Nomination Form
Anadromous Waters Catalog

Anadromous Waters Catalog Number of Water Body 212-10-10010-2041-3015-

Nomination # <u>24-972</u>	<u>Adam Reim</u> Fisheries Scientist Date <u>12-17-2024</u>
Revision Year: <u>2025</u>	<u>Ron Bentz</u> Habitat Operations Manager Date <u>12/5/2024</u>
Revision to: ☒ Atlas ☒ Catalog	<u>Joseph Dyer</u> AWC Project Biologist Date <u>22 Nov 2024</u>
Revision Code: <u>A-2d, C-9</u>	<u>P. L.</u> GIS Analyst Date <u>12/19/2024</u>

Map #1

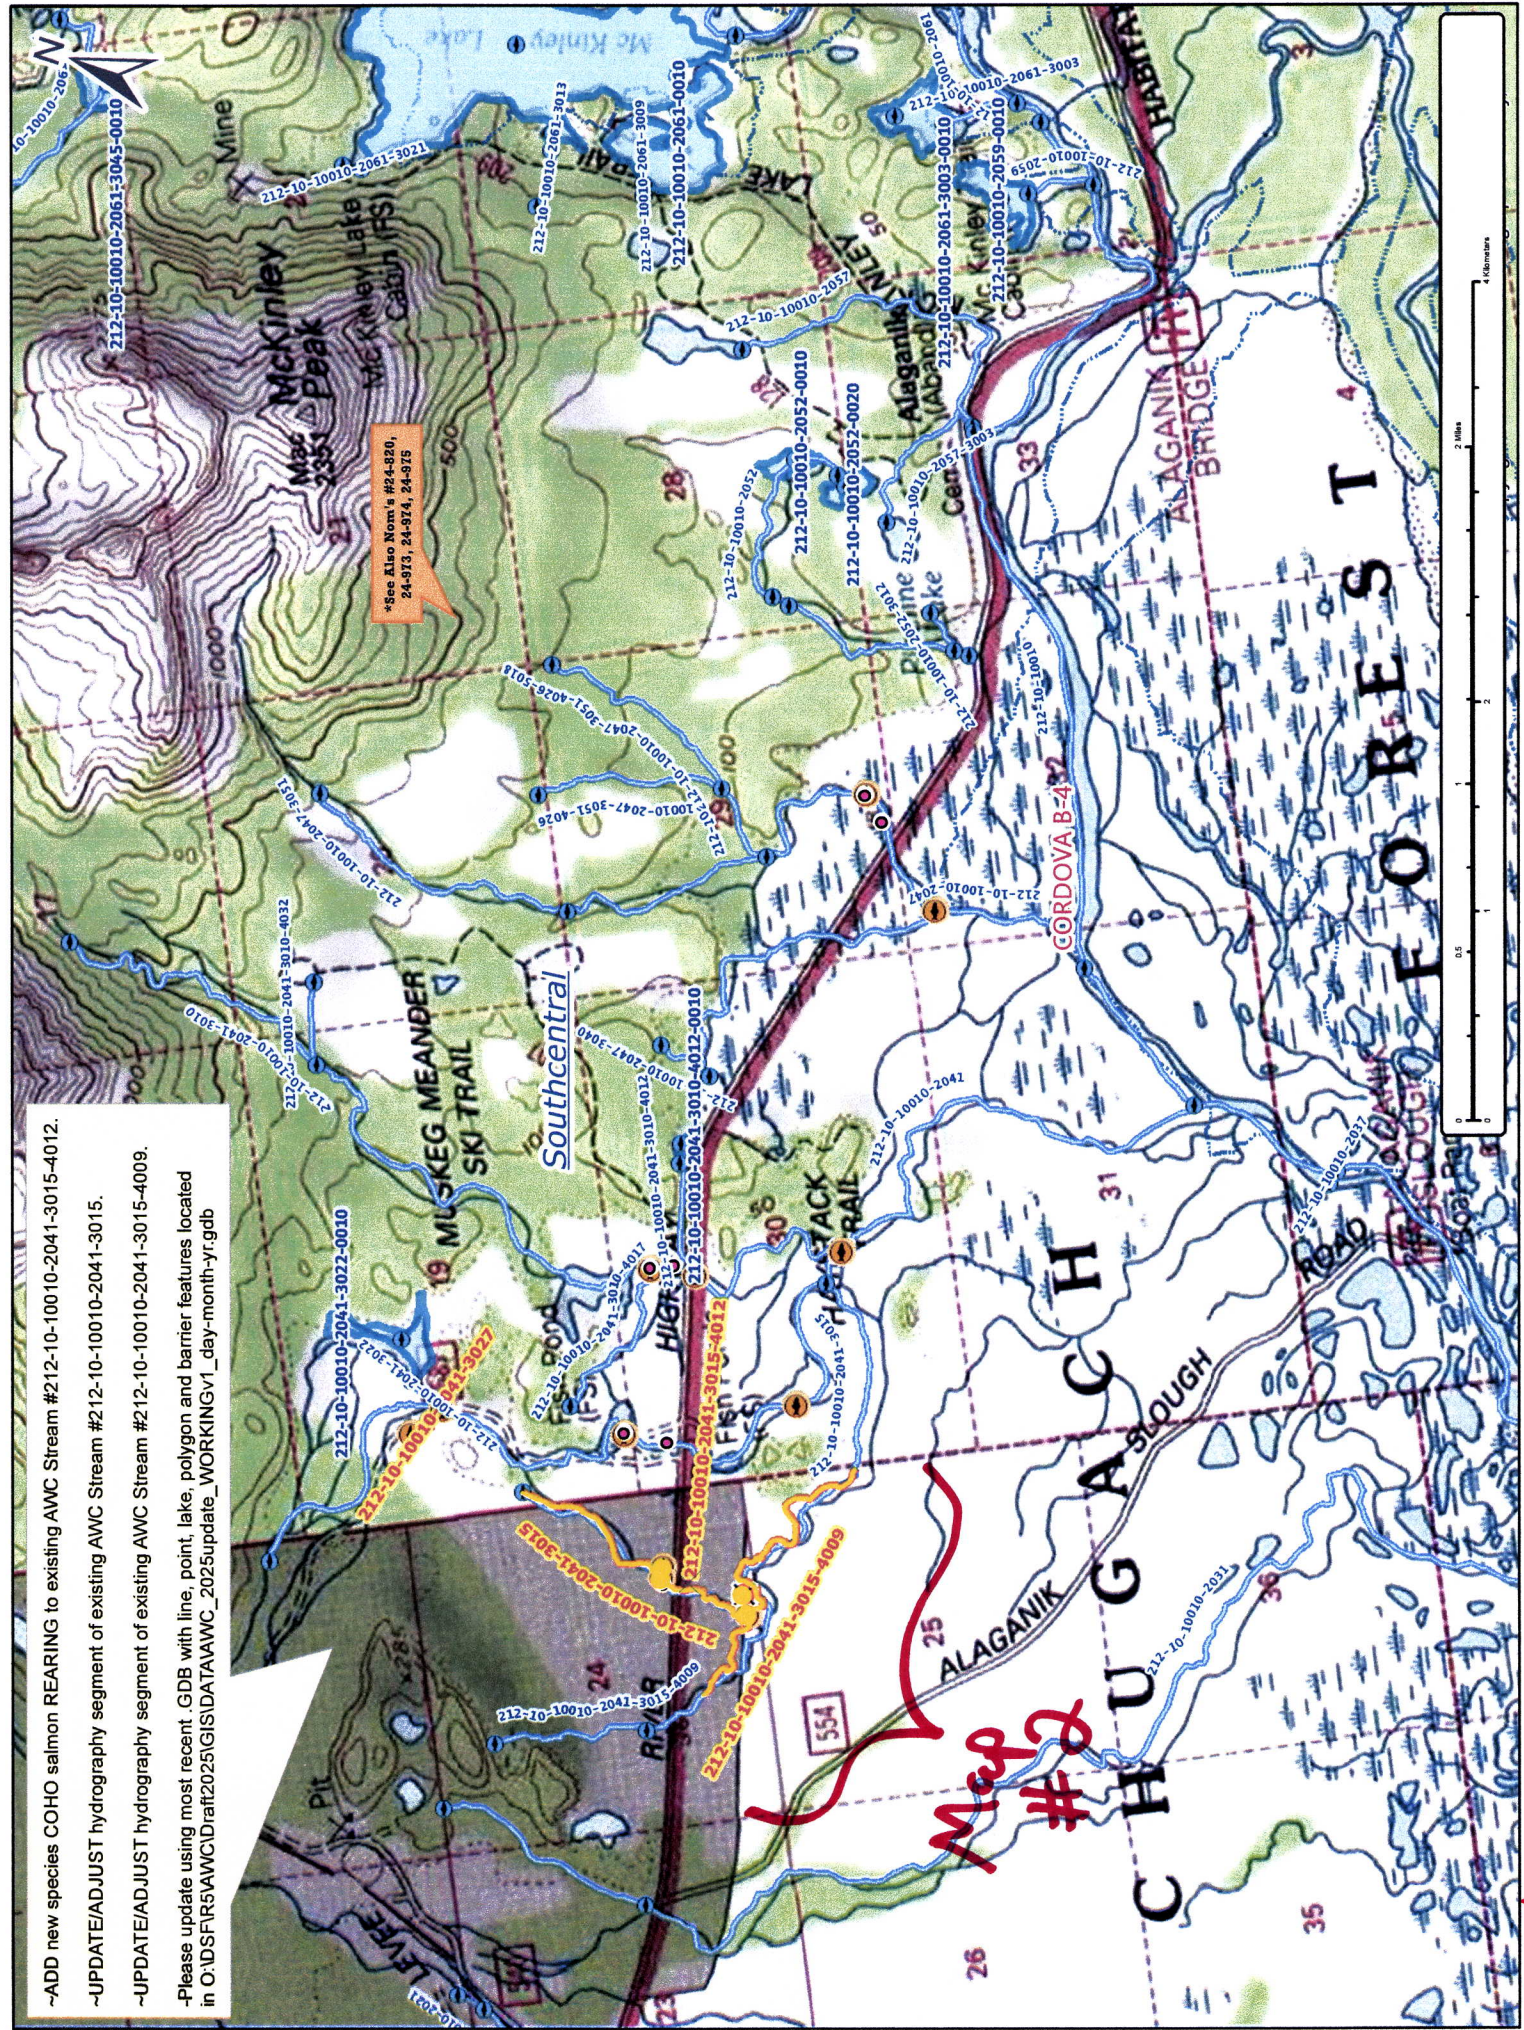
~ADD new species COHO salmon REARING to existing AWC Stream #212-10-10010-2041-3015-4012.
 ~UPDATE/ADJUST hydrography segment of existing AWC Stream #212-10-10010-2041-3015.
 ~UPDATE/ADJUST hydrography segment of existing AWC Stream #212-10-10010-2041-3015-4009.
 ~Please update using most recent GDB with line, point, lake, polygon and barrier features located
 in O:\D\FIR5\AWC\IDraft\2025\GIS\DATA\AWC_2025update_WORKINGv1_day-month-yr.gdb

Map #2

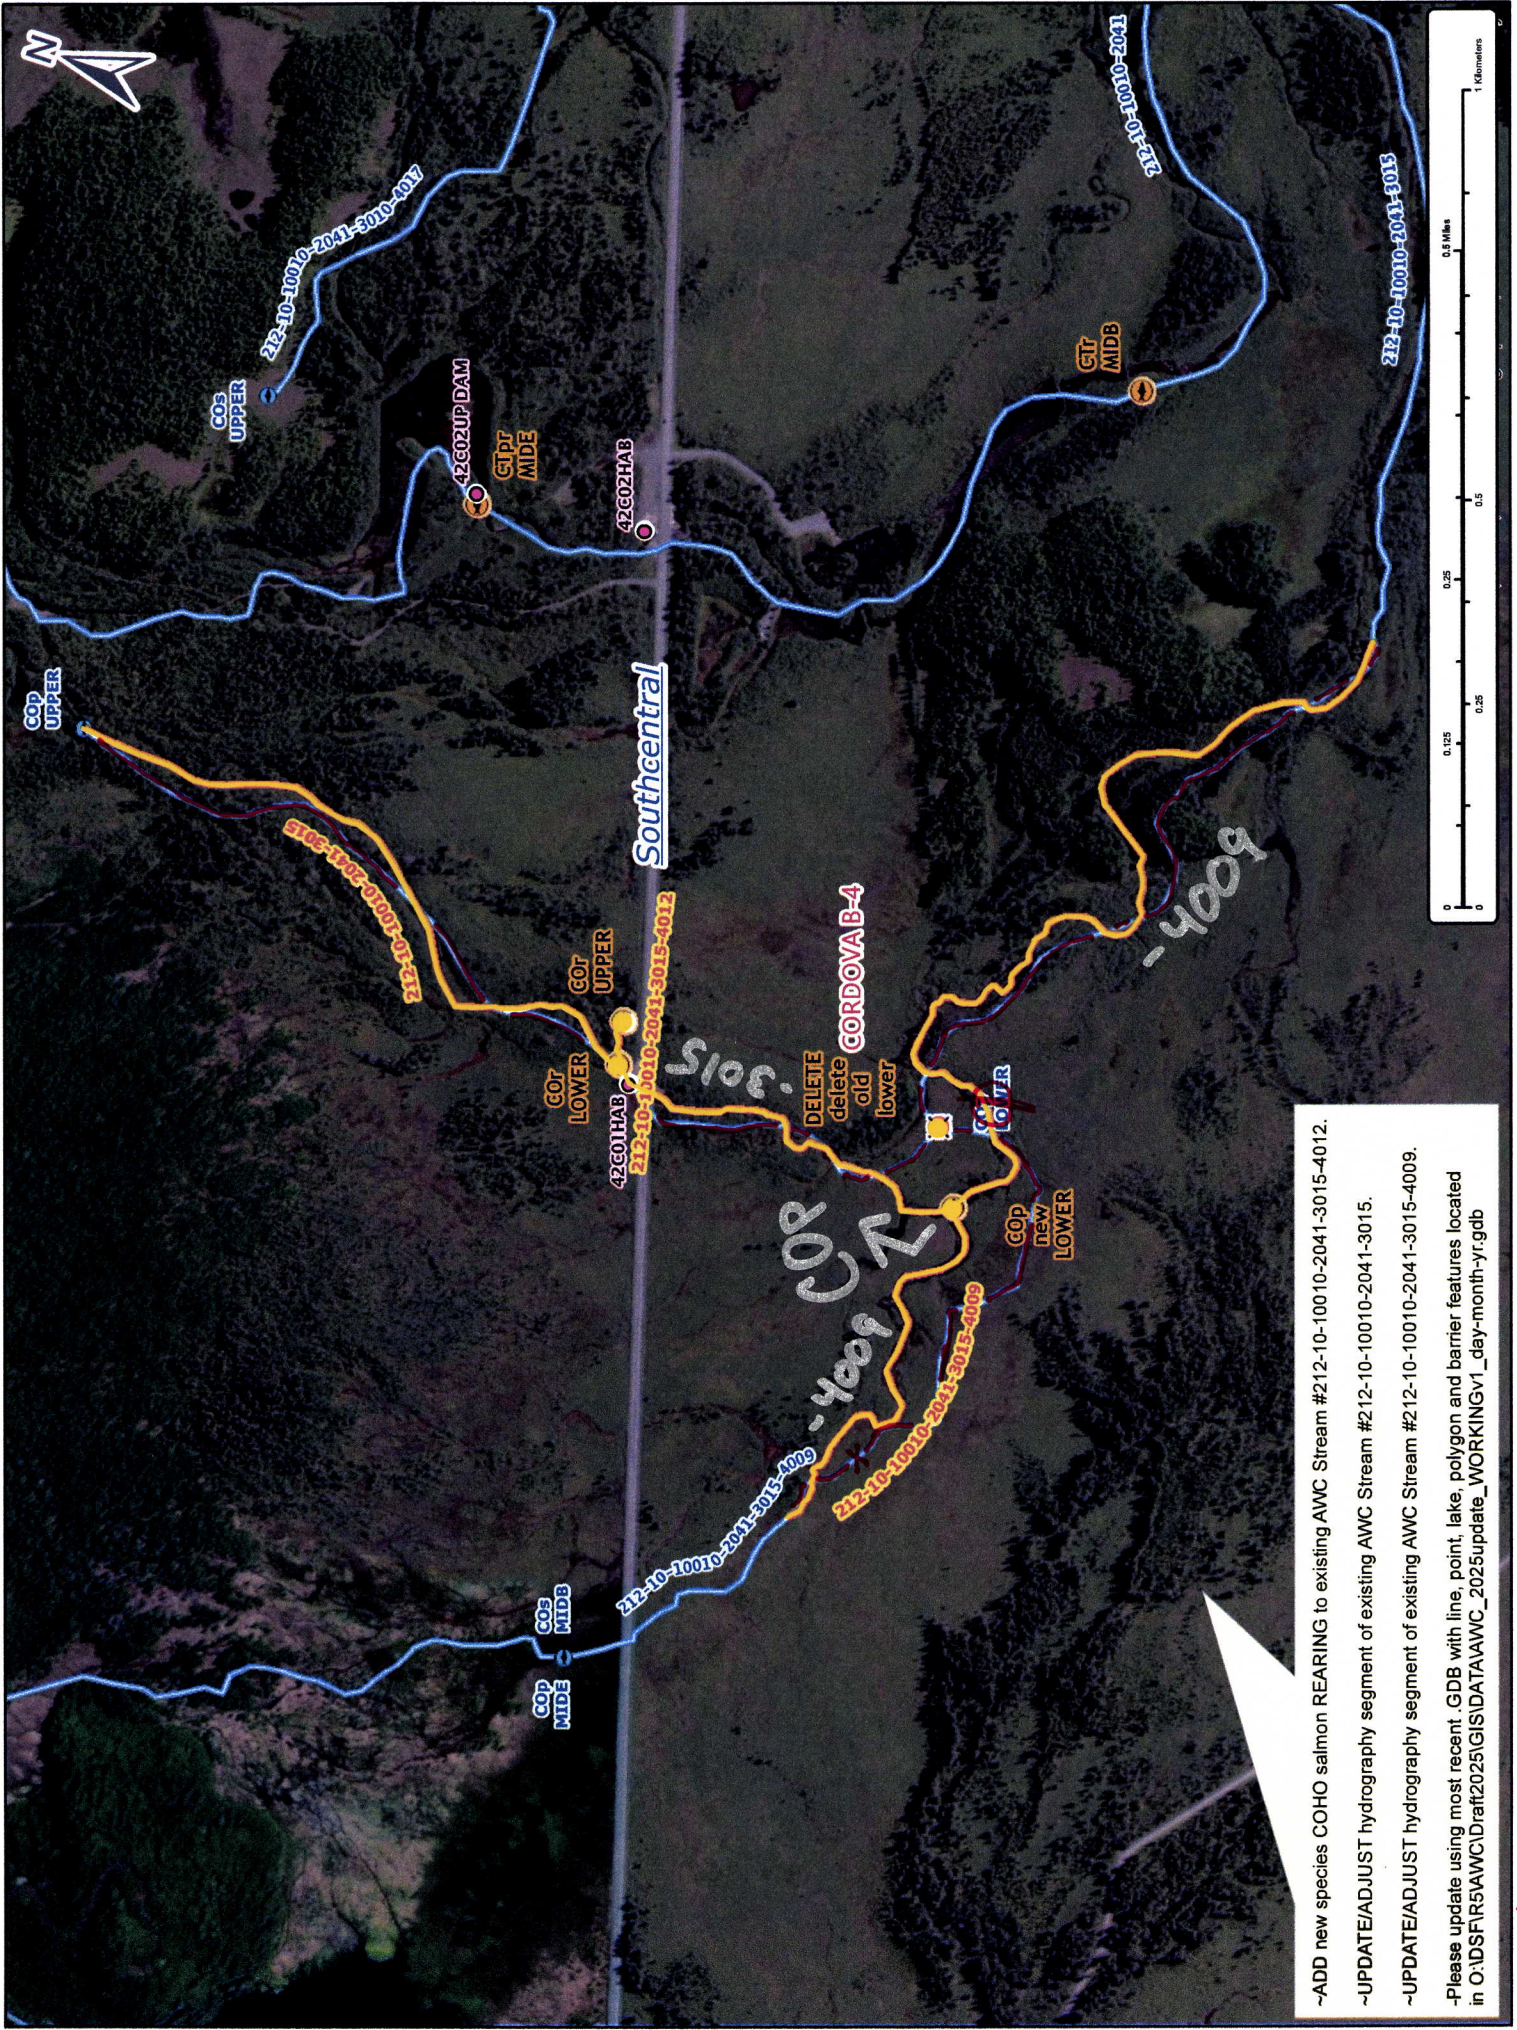
~ADD new species COHO salmon REARING to existing AWC Stream #212-10-10010-2041-3015-4012.
 ~UPDATE/ADJUST hydrography segment of existing AWC Stream #212-10-10010-2041-3015.
 ~UPDATE/ADJUST hydrography segment of existing AWC Stream #212-10-10010-2041-3015-4009.
 -Please update using most recent GDB with line, point, lake, polygon and barrier features located
 in O:\DSF\IR5\AWC\Draft2025\GIS\DATA\AWC_2025update_WORKING\GI_day-month-yr.gdb

Map #3

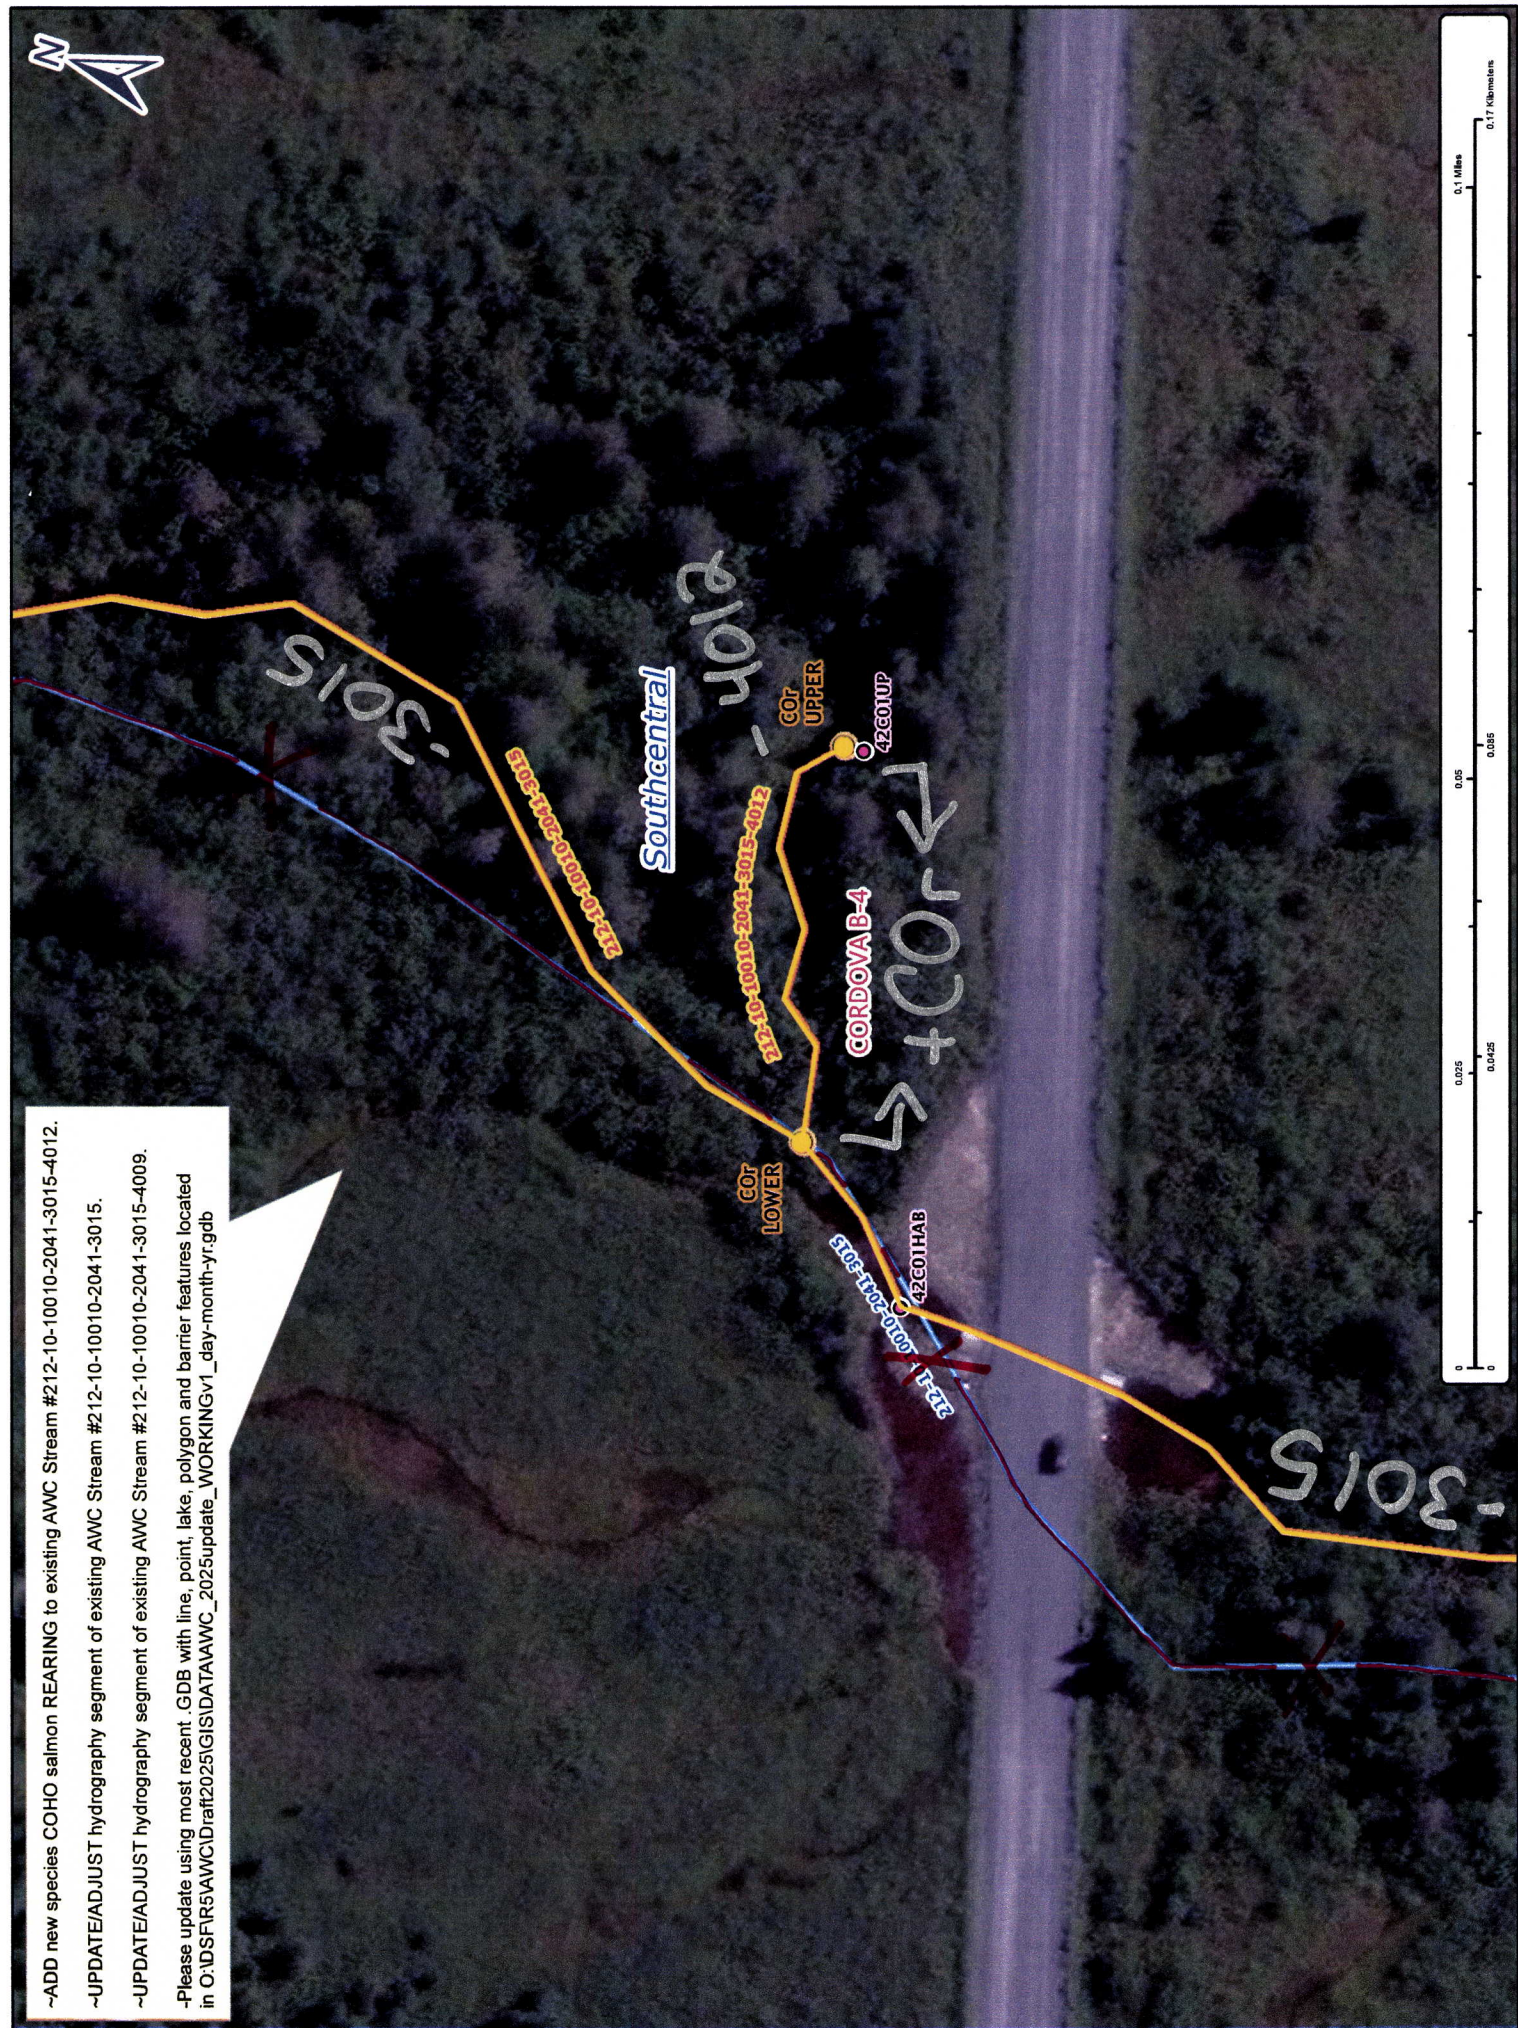
~ADD new species COHO salmon REARING to existing AWC Stream #212-10-10010-2041-3015-4012.
 ~UPDATE/ADJUST hydrography segment of existing AWC Stream #212-10-10010-2041-3015.
 ~UPDATE/ADJUST hydrography segment of existing AWC Stream #212-10-10010-2041-3015-4009.
 ~Please update using most recent .GDB with line, point, lake, polygon and barrier features located
 in O:\DSFIR5\AWC\Draft2025\GIS\DATA\AWC_2025update_WORKING\Gv1_day-month-yr.gdb
